# Technical Bulletin

# No.CGO-001

**SUBJECT:** Service Manual Correction

FAX5600L

## Harness Check Procedure

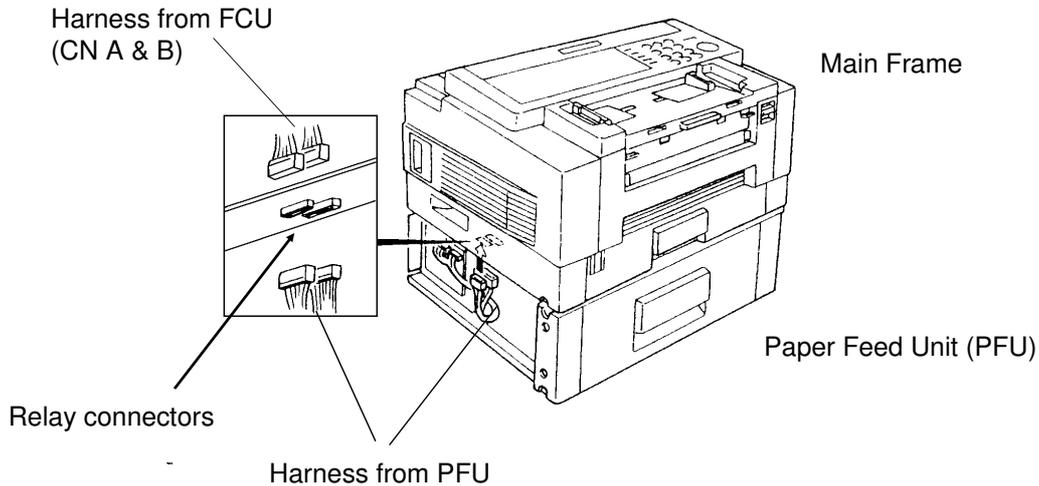
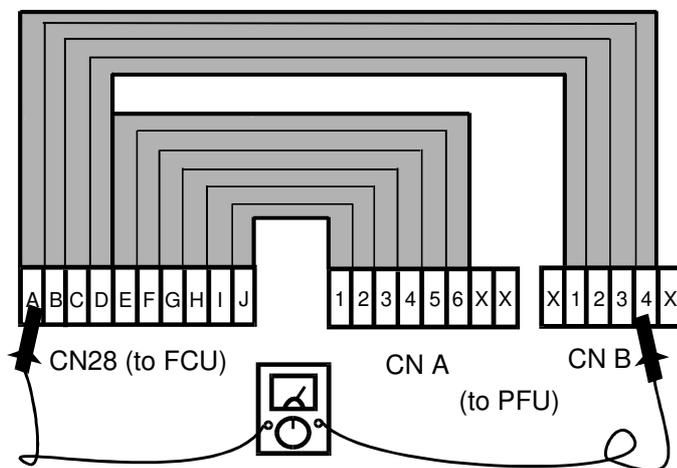
The harness should be checked before the start of the PFU installation because the FCU or the PFU PCB may become damaged.

Follow the attached procedure before PFU installation and change the harness to a new one if it is bad.

1. Remove the Rear Cover and Left Cover.
2. Unplug the connector CN28 on the FCU.
3. Unplug the connectors CN A and CN B on the relay connector board located at the bottom of Main Frame.

4. Check the continuity of the harness pin by pin using a multimeter.  
See below for what the correct allocation of all wires of the harness should be.

**Hot Roller Kit:**

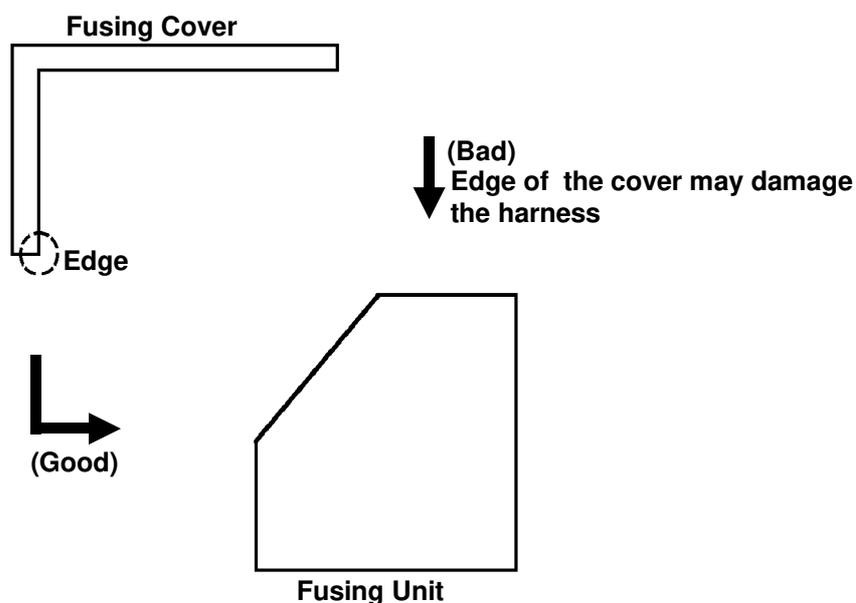
Hot Roller failure as a result of not changing the Cleaning Pad at the 10K PM. Failure to change the Cleaning Pad results in dirty Strippers and Thermostat and then Hot Roller failure.

Ricoh recommends replacing the Cleaning Pad at the 10K PM. However, this is sometimes ignored. Realizing this, Ricoh will conduct the following modifications to protect the Hot Roller from the failure mentioned above.

The hot rollers shipped from the SPC in Japan will be replaced by the Hot Roller Kit in July.

This kit will be comprised of the following: Hot Roller, Cleaning Pad, Thermistor, Thermistor Bracket, Screw, Strippers (2), Stripper Springs (2) and Installation Sheet. The individual Hot Roller will be no longer available. The Cleaning Pad will continue to be a Service Part.

Ricoh recommends change of the above modified parts and Cleaning Pad when the failed Hot Roller is replaced with the new one.

## Installation Procedure for the Thermistor

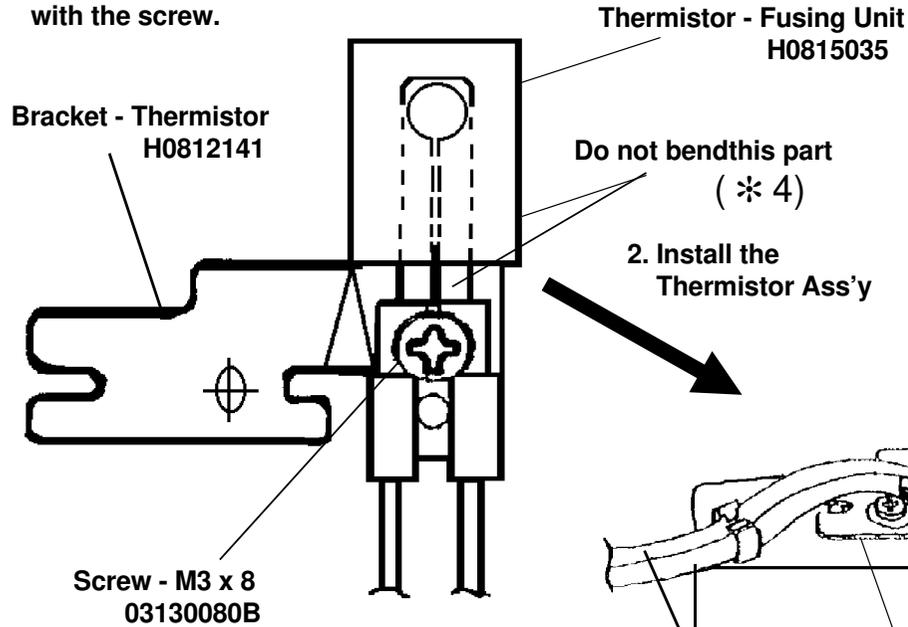
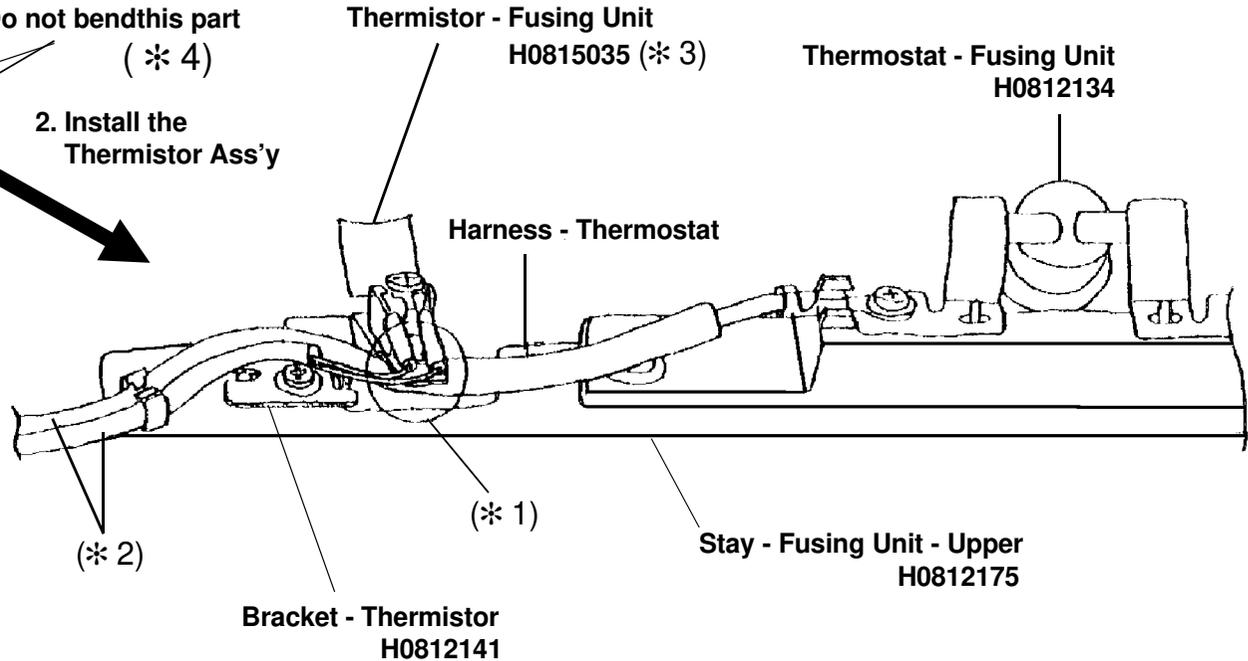
**If the metal wire of the harness contacts the thermistor bracket, a no power condition may occur. Please check the thermistor harness if this occurs.**

1. Assemble the thermistor and the bracket with the screw.

Do not bend this part (\* 4)

2. Install the Thermistor Ass'y

- Note: \* 1 Place the thermostat harness under the part of the bracket.
- \* 2 Do not cross the thermostat harness and the thermistor harness.
- \* 3 Push the thermistor head (sensor) gently against the hot roller with a finger to make sure that the thermistor head touches the hot roller surface. Do not push it strongly.
- \* 4 Do not bend the thermistor neck (spring plate) when installing or cleaning it .  
If the thermistor is bent, replace it.
